AVR128DB28/32/48/64

AVR128DB28/32/48/64 Silicon Errata and Data Sheet Clarifications

Figure 3-1. I_{DD} Over V_{DD} and Temperature With IRSEL = 0

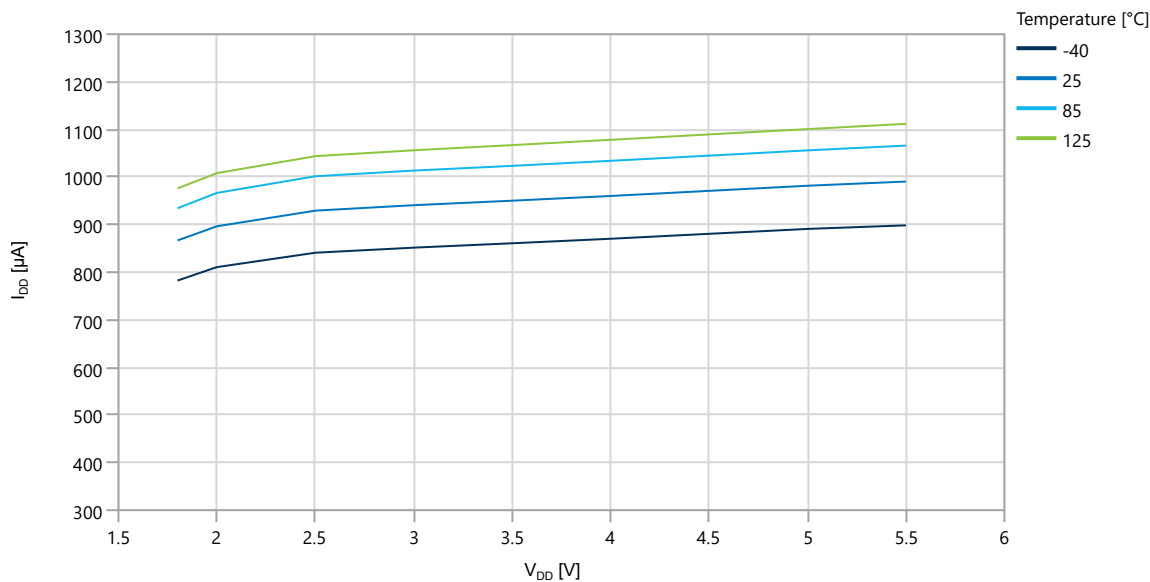
Some additional plots are added to the OPAMP section of the Typical Characteristics:

Note: This plot is only valid for revision A5 and later.

Figure 3-2. I_{DD} Over V_{DD} and Temperature With IRSEL = 1

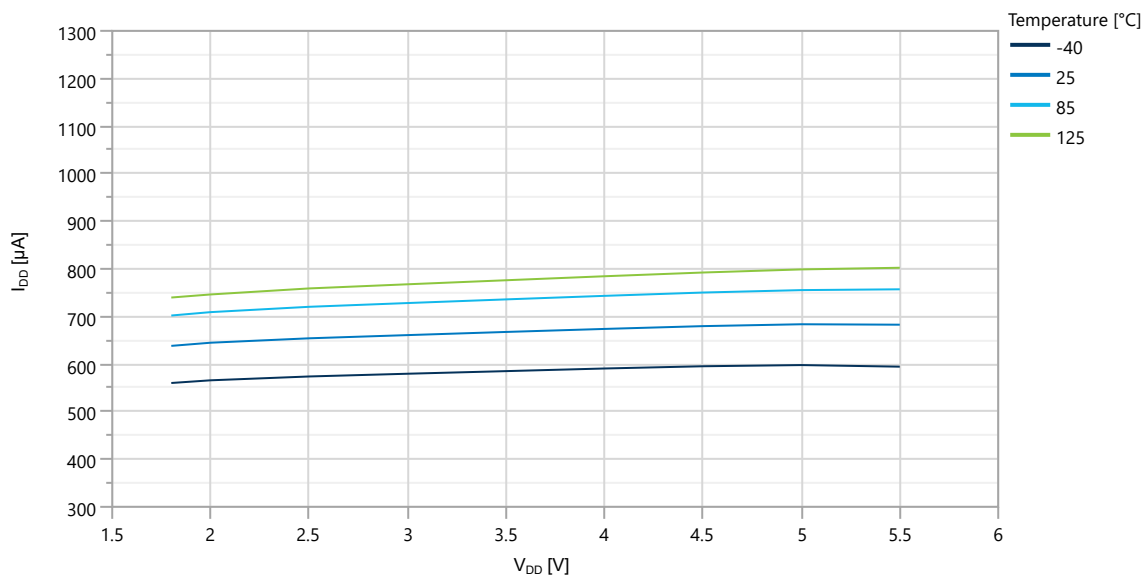
Note: This plot is only valid for revision A5 and later.
